**REPRESENTATION OF, OR THE NEGLECT OF, DRIPPING FROM ROCK BOLTS
IN THE ENHANCED CHARACTERIZATION
OF THE REPOSITORY BLOCK CROSS-DRIFT
(RESPONSE TO TSPA 3.07 AND GEN 1.01 (COMMENTS 13 AND 95))**

This appendix provides responses for Key Technical Issue agreement Total System Performance Assessment and Integration (TSPAI) 3.07 and General Agreement (GEN) 1.01 (Comments 13 and 95). This KTI agreement relates to the U.S. Department of Energy (DOE) representation of, or neglect of, dripping from rock bolts in the Enhanced Characterization of the Repository Block (ECRB) Cross-Drift in performance assessments.

J.1.1 TSPAI 3.07 and GEN 1.01 (Comments 13 and 95)

Figure J-1. Model to Evaluate Effect of Rock Bolt

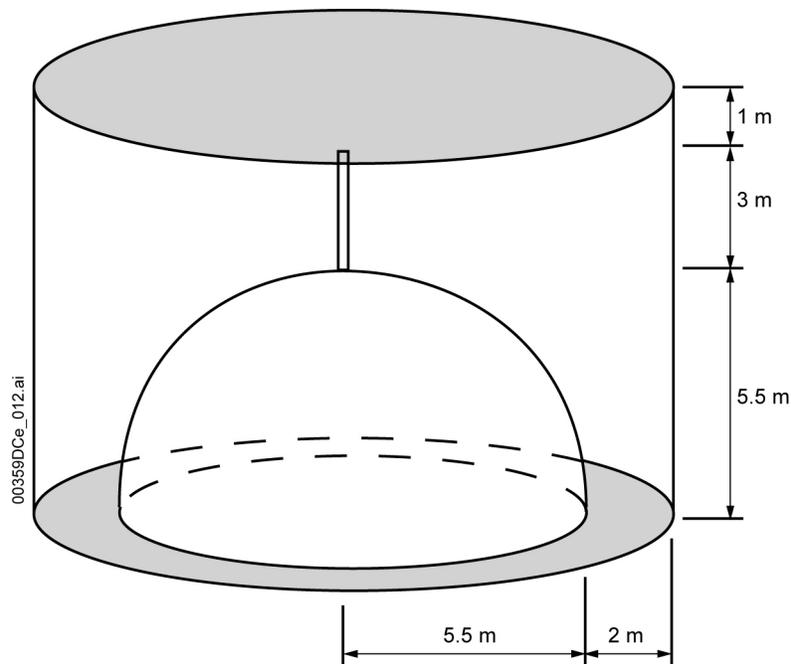
The SSPA argues that rock bolts will not enhance seepage, contrary to the Seepage Model for PA including Drift Collapse AMR, which indicates increased seepage due to rock bolts.

Basis: Puddles of water were observed directly under rock bolts in Alcove 5. An explanation provided by DOE for this observation was that water was used for drilling these rock bolts in place. Dripping has been observed from rock bolts in the sealed ECRB. The explanation provided by DOE (so far) for this observation is that this is condensation.

A model has been developed for evaluating the effect of rock bolts on seepage. The model includes both grout and no-grout cases. Because the current design excludes the use of grout in emplacement drifts (BSC 2004b), only the no-grout case was evaluated. Using the model, a range of properties for the formation, including the no-grout case for a mechanically anchored bolt and a range of percolation rates, was investigated. Figure J-1 shows a schematic of the model. The model uses a two-dimensional, radially symmetric grid with a vertical symmetry axis generated using the software TOUGH2 V1.4 (LBNL 2000). The grid size is 10 cm, with finer discretization (down to 0.1 mm) at the interface between the rock bolt and the surrounding rock. Because this is a radially symmetric grid, the drift opening is spherical instead of cylindrical. Knight et al. (1989, p. 37) find that seepage exclusion from a cylindrical cavity is similar to that of a spherical cavity of twice the radius. This is explained by relating the seepage exclusion potential of an opening to the total curvature of the boundary of the opening. For a cylindrical cavity, the radius of curvature is infinite along the axis of the cylinder and finite perpendicular to the axis. For a spherical cavity, the radius of curvature is finite and equal in any

To investigate the effect of a rock bolt on seepage, only the case of a rock bolt borehole extending vertically upward from the crown of the drift was modeled. Rock bolts at different angles will not have a larger effect on seepage than rock bolts at vertical angles. If there is negligible effect on the model, this case is sufficient to resolve the question of the effect on seepage caused by rock bolts, because the presence of the rock bolt borehole will not significantly change the calculated seepage values. Three grids are prepared to explore diversion capacity away from the rock bolt borehole. Case 1 allows flow between the rock bolt borehole

Results for the Effect of Rock Bolts—Modeling results for seepage enhancement caused by the presence of a vertical rock bolt are shown in Table J-1. Here, a seepage enhancement factor is defined as:

Thus, the enhancement factor is negative if the seepage increases because of the presence of a rock bolt and is positive if it decreases. Table J-1 shows results only for a percolation flux (Q_p) of 500 mm/yr because, with a percolation flux of 5 mm/yr, seepage rates in all cases are 0, and enhancements are also found to be 0. In Table J-1, cases C1, C2, and C3 represent three variations in mesh design for representing connections between rock bolt boreholes and the rock. As shown in Table J-1, seepage enhancement is negligible. This result is understandable, considering that the cross-sectional area of the rock bolt borehole, which may be intersected by flow, is small and that the borehole can exchange moisture with the rock along its length. For a vertical rock bolt, if only the horizontal surface is considered, the area is about 0.002 m². For a nonvertical rock bolt, because the area of rock bolt projected onto a horizontal plane is larger, the potential for flow from the rock bolt borehole to the rock matrix around it is also increased.

The results are not sensitive to the alternative mesh design cases C1, C2, and C3. Furthermore, since the changes are very small, the presence of five or six rock bolts do not change seepage significantly.

Figure J-4. Condensate on Shotcrete after Second Bulkhead

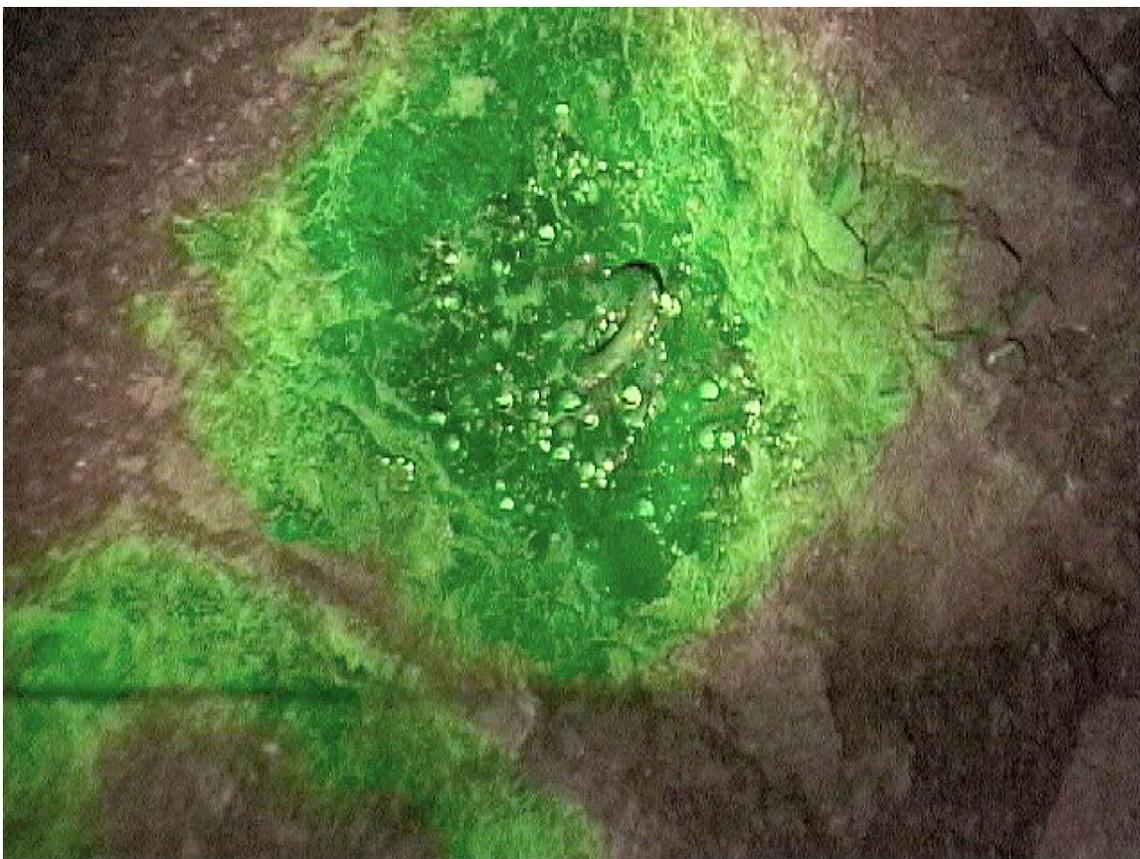
NRC indicated that the dripping observed in the ECRB Cross-Drift may result from vapor-phase mobilization of water and condensation on surfaces of rock bolts, ventilation ducts, and utility conduits under small thermal gradients. In an unventilated near-field environment, where waste-canister heat causes spatial temperature variability, this process could result in significant dripping. Condensate could react with metal at elevated but below-boiling temperatures. Dripping in the ECRB Cross-Drift may also have resulted from seepage into the drift. Data are not sufficient to conclusively determine whether water observed in the ECRB Cross-Drift was condensate or seepage. However, two factors suggest that condensate contributed to the observed water in the ECRB Cross-Drift rather than seepage: (1) visual observations of droplets on impermeable engineered materials, such as a vent tube, a conveyor belt, and overhead cables (Section J.4.2.1); and (2) chemical analysis of water (Section J.4.2.2). These factors are documented in *In-Situ Field Testing of Processes* (BSC 2003d). Although seepage may also occur in the sealed drift, the available data do not conclusively identify the source of water as being seepage.

Visual and photographic observations on October 1, 2001, in the bulkhead at Station 17+63 indicated dry stalactites on the vent tube just inside of the first bulkhead (Figure J-2). The deposits were probably from redistribution of vent tube materials from dissolutions associated with early condensations, driven by temperature variations near the bulkhead. The lights in the same area have precipitate on them but were dry during the observation. The drift was dry from the first bulkhead to about Station 18+00.

The drift was wet from Station 18+00 to about Station 19+00. The first sign of moisture was observed on the left rib at Station 17+90, with drips on utility conduits. The dripped water on the utility conduits appeared slightly rusty. Vent lines and walls were uniformly covered with liquid, and there were puddles on the belt. There was a large puddle on the conveyer belt at Station 18+25 (Figure J-3).

Dampness was prevalent on the shotcrete after the Station 25+03 bulkhead (Figure J-4) and behind the Station 25+99 bulkhead. The drift was dry again from Station 19+00 to about Station 21+50. The walls began to dry out towards the tunnel boring machine.

From observations on October 2, 2001, after the bulkhead doors were left open overnight, most of the water droplets from the previous day had evaporated, with some of the rock remaining damp. A patch of paint on the rock surface was observed to have beads of water on its surface, with no similar beads observed on the surrounding rock surfaces (Figure J-5). Since the paint is impermeable, the observed beads were likely the results of condensation, not of seepage through the rocks below the painted patch. This observation supports the hypothesis that the observed water originated from condensation as the result of local temperature variations.
